Design Change
Request No. 25_128

Customer project Name/ 客户项目名称: JIM-4JJ MCR No. / MCR号:

PDEC R25-128 (4JJ1-D 样件)

PDECR 25-128

零件号		零件名称	Project	样件阶段	变更来源
F01Z5017P5-05		BRACKET	J1e-4JJ	D	BOSCH/Customer
变更前		变更后			
F01Z5017P5-05

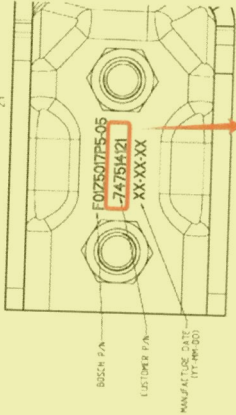
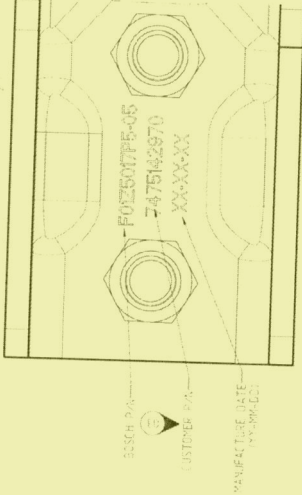
变更描述					
		客户料号更新为 7475142970			
变更原因		客户要求			
风险点 (影响)		无			
验证方法		无
